<u>DATE</u>	April 10, 2024
<u>SUBJECT</u>	
<u>Certificate of Appropriateness Request:</u>	H-06-24
<u>Applicant:</u>	Cameron Watson and John Craver
<u>Location of subject property:</u>	36 Yorktown St NW
<u>PIN:</u>	5620-77-8897
<u>Staff Report prepared by:</u>	Kim Wallis, AICP, Senior Planner

Close up of existing side profile where changes are proposed:

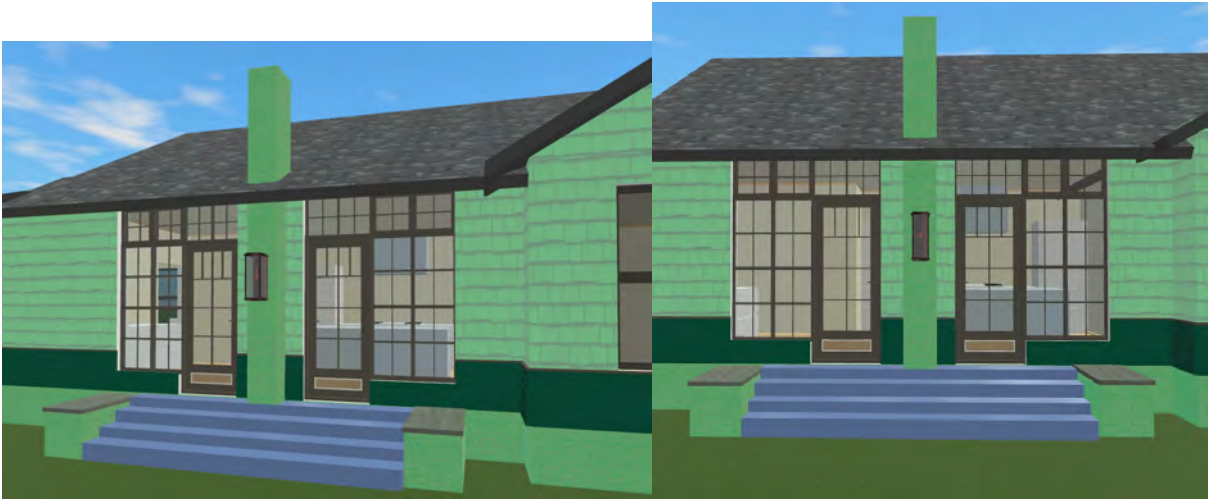
- Replacement of 2 small windows and home siding with 2 large windows and doors flanking the existing chimney (see image above). These windows and doors will be custom fabricated to match the glass and pane characteristics of the home's front sunroom. See photos at the end of this document that illustrate windows.
- Construction of steps to emulate front steps. These will be poured concrete steps flanked by masonry brick end caps topped with flat concrete pediment. See photos below. We will match these steps as closely as possible.

- Removal of existing crepe myrtle in front of proposed steps.
- Moving the existing A/C unit from our driveway side of the home to the opposite side. It will not be visible from the road. The 12-year-old A/C only system will be replaced by a new Trane heat pump.
- Installation of a gas lantern (22x9in.) affixed to the preexisting kitchen chimney.
- <https://frenchmarketlanterns.com/nouveau-wall-mount-bundle.html> (see image below)

CRAWLSPACE

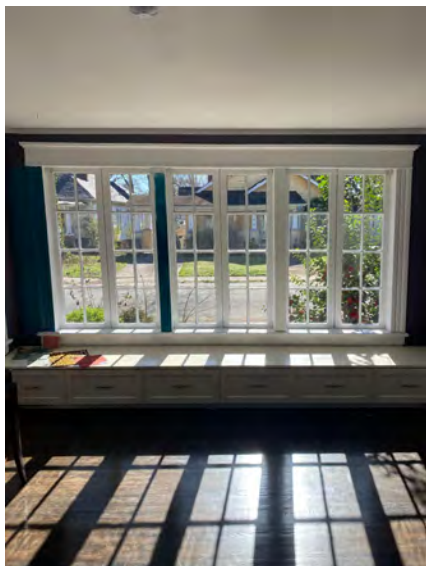
2. Water intrusion into crawl space. The large tree's root system is a contributing factor of why the home's foundation has cracked in places, allowing water to enter the crawl space.

Standing water and wet soil was present in one or more areas of the crawlspace. Evaluation of the source of the water and/or water infiltration with repairs made as needed to prevent or manage the water intrusion is recommended to be performed by a foundation contractor, grading contractor, waterproofing contractor, or other qualified person as needed.

Contact a foundation contractor.
